Village of Arlington Heights
Plat and Subdivision Committee
Community Room, 3rd Floor
Arlington Heights Village Hall
33 S. Arlington Heights Road
Arlington Heights, IL 60005
June 22, 2016
6:30 PM

STAFF DEVELOPMENT COMMITTEE REPORT

To: Plat and Subdivision Committee
Prepared By: Sam Hubbard, Development Planner
Meeting Date: June 17, 2016
Date Prepared: June 22, 2016
Project Title: Our Savior's Lutheran Church Columbarium
Address: 1234 N. Arlington Heights Rd.

Project Name and Address	
SITE PLAN A1

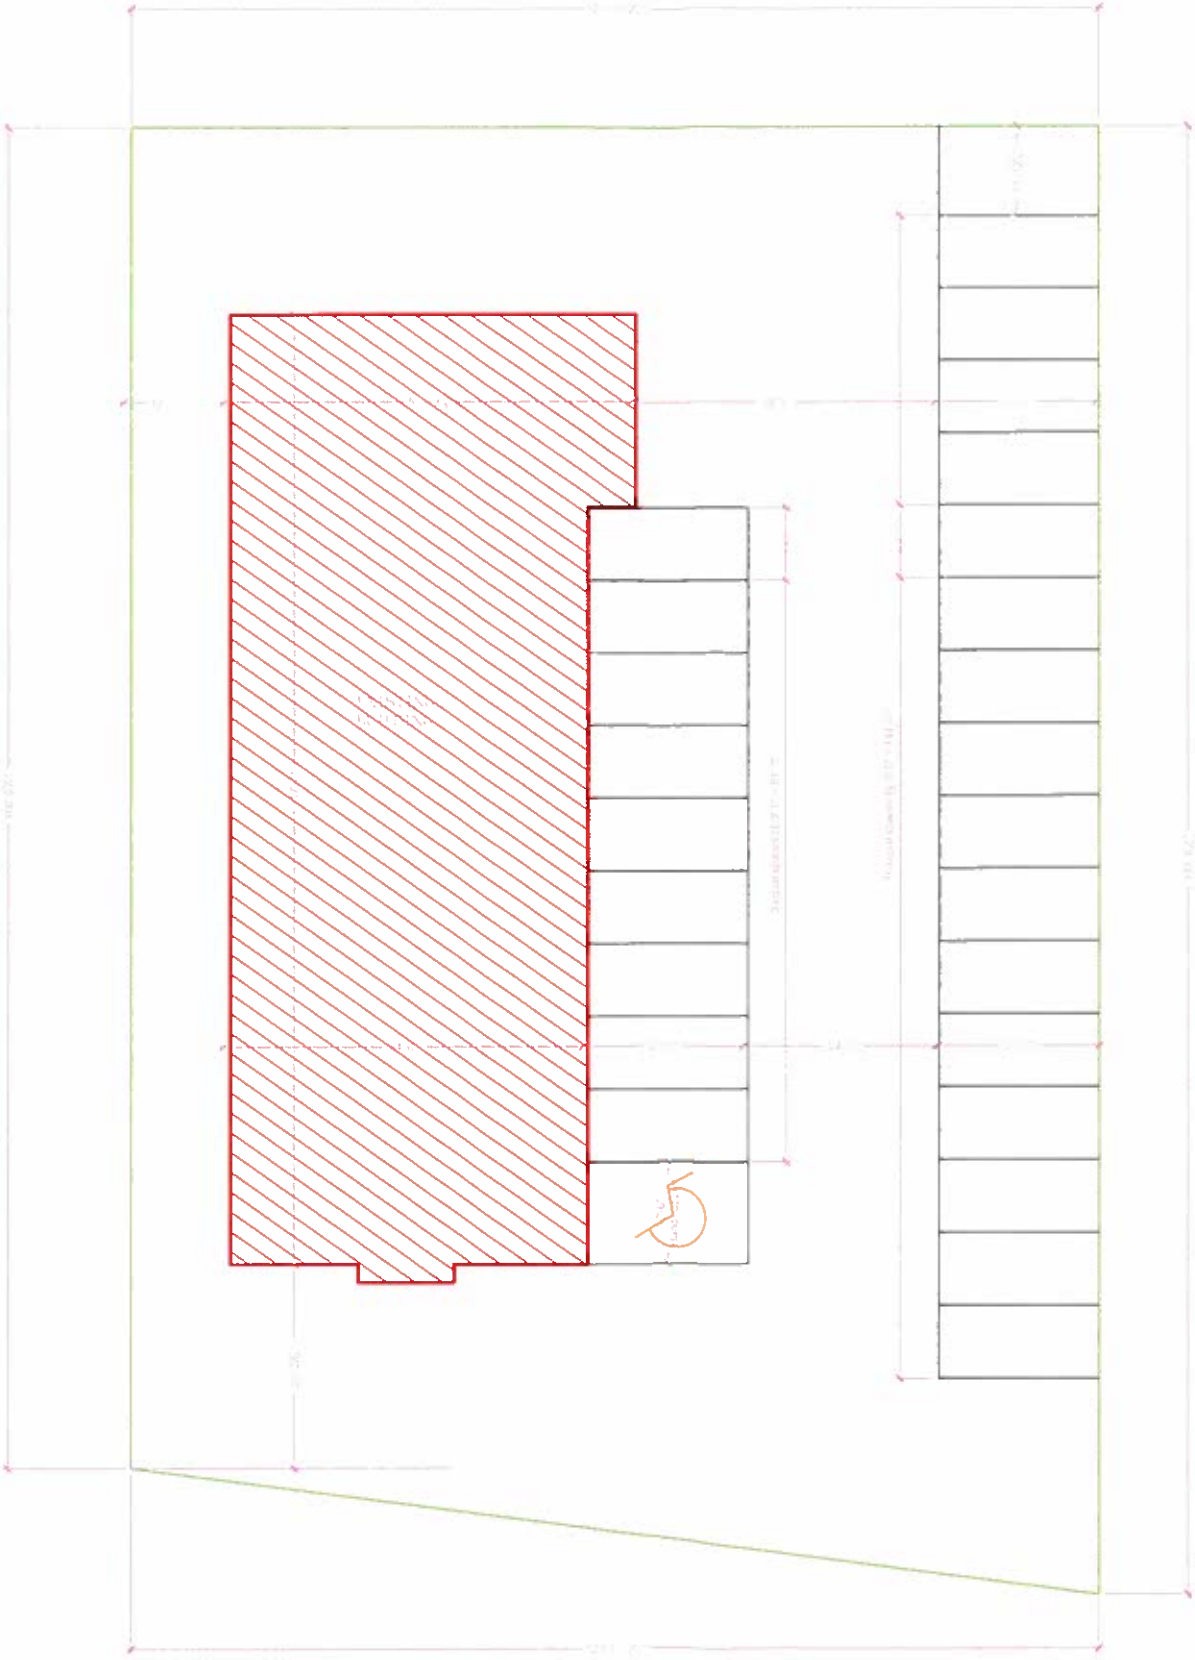
The subject property appears to conform to all parking space requirements. However, the petitioner should clarify how many parking spaces are actually located on the site. Conflicting information exists when comparing the number of parking spaces provided by the petitioner and the number of parking spaces as shown on the site plan. Additionally, the site plan should reflect the existing access point to the Japan Auto site as the plan currently shows parking in this location.

As part of the Japan Auto approval in 2012, a condition of approval was included that required a Reciprocal Easement Agreement (REA) be established should the shared access between the two properties be constructed. As this shared access has been constructed, the petitioner is requested to clarify if the required REA has been established.
